October 17, 2011
Project No. 0647-01-36-42-02

Re: Response to Permit Modification NOD
Passive Vent Installation
Castle Drive Landfill - MSW Permit No. 1062A
Dallas County, Texas
Tracking No. 14834289; RN100221225 / CN600328694

**CITY OF GARLAND CASTLE DRIVE LANDFILL
DALLAS COUNTY, TEXAS
MSW PERMIT NO. 1062A**

**ATTACHMENT 14
LANDFILL GAS MANAGEMENT PLAN**

2011 REMEDIATION PLAN
SITE PLAN

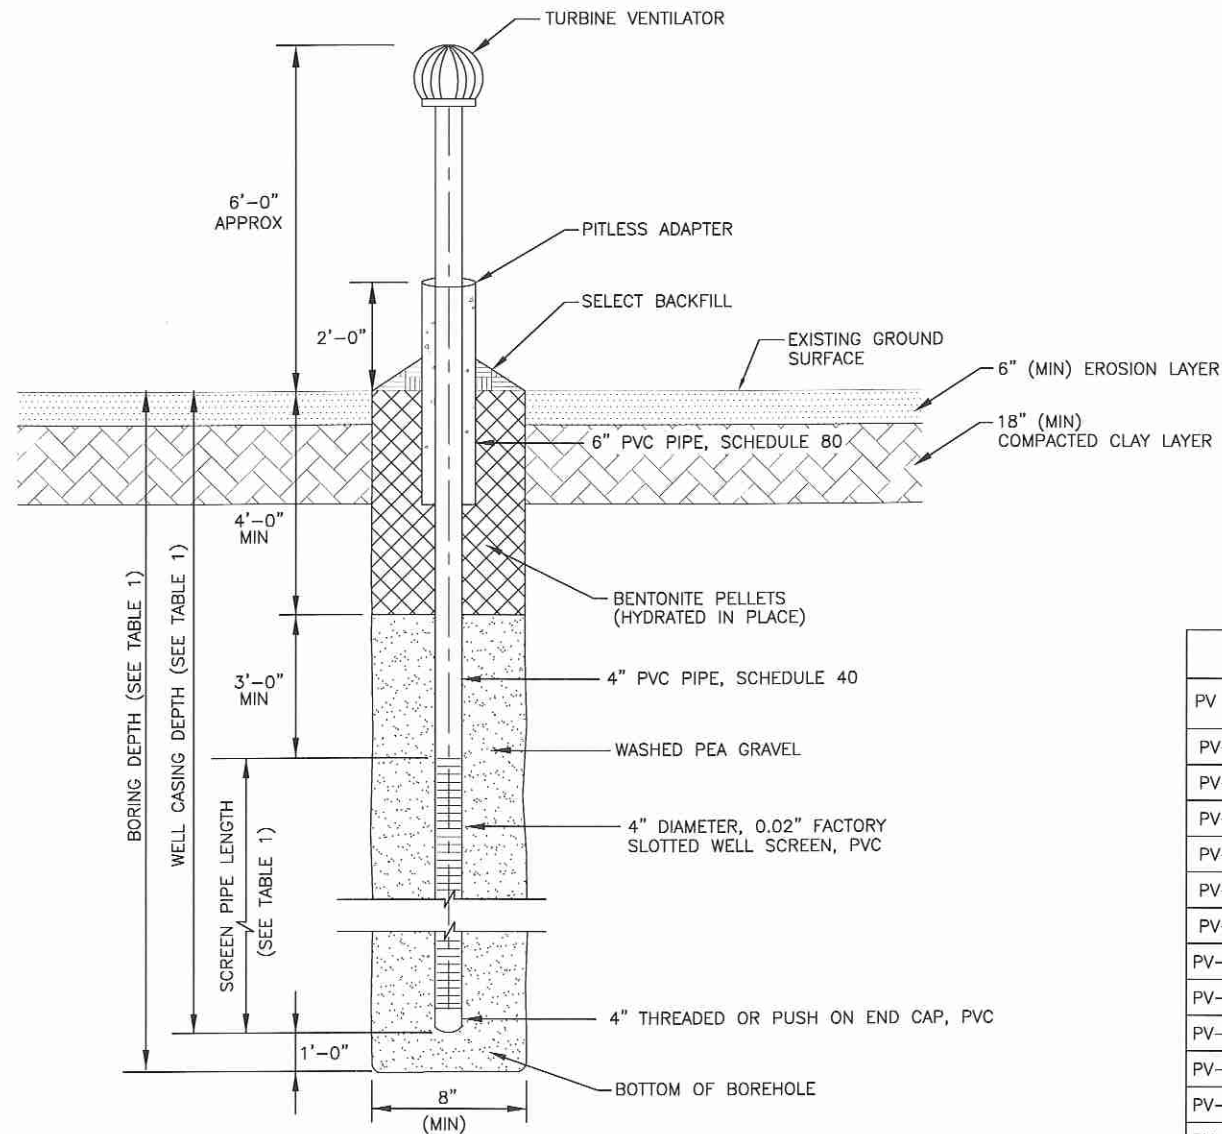
- a. It appears that four of the existing LFG extraction wells (EW) to the west of EW-43 have been removed from the currently approved Site Plan. Please retain these LFG EWs or provide an explanation of why they were removed.**

- b. **In Section 6.0, LFG Control System Installation and Monitoring, it states that three existing vents near PP-9 were converted to active soil vapor extraction wells. However, it appears that these wells are labeled as passive vents (PV) on Attachment H2. Please revise the drawing and names of the wells to reflect their conversation to extraction wells.**

Attachment H2 is not being revised and is to remain as previously approved as described in response to comment #4. However, there are five existing extraction wells to the west of EW-43 which are numbered as EW-74 through

EW-78 in the drawing Attachment H4. These five wells were installed as part of the permit modification submitted to the TCEQ dated May 14, 2002 and TCEQ approved the permit modification dated May 29, 2002.

Attachment H2 is not being revised and is to remain as previously approved as described in response to comment #4. However, as requested, PP-1 through PP-3 labels has been revised as shown in Attachment H4.

PASSIVE VENT
(INSIDE LIMITS OF WASTE) 2
H5
NTS

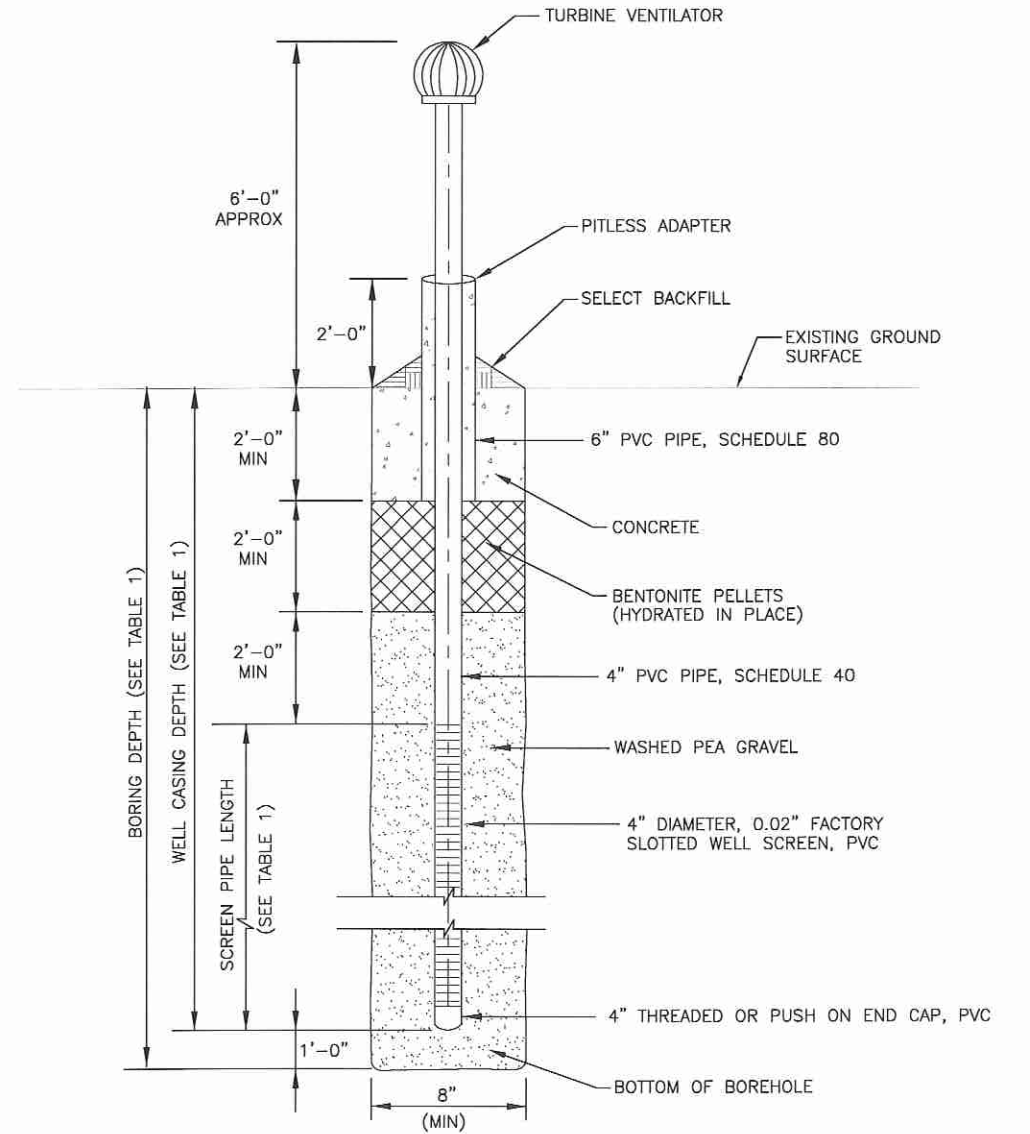
4. **It appears that Attachment H3, Trench/Passive Vent Location, included in the permit modification regarding the Remediation Plan for Probe PP-9 issued June 15, 2010 has been replaced by Attachment H3, Passive Vent Details in the current submittal. Please retain the currently approved Attachment H3, Trench/Passive Vent Location, and provide an additional figure in Attachment H of the Landfill Gas Management Plan for the passive vent details related to the most recent**

As requested, we are not revising Attachments H2 and H3 and they are to remain as previously approved. In order to add/update the new LFG features at the site, Attachment H4 through H7 has been included in Appendix H. The following summarizes the additional documents added to the existing Appendix H.
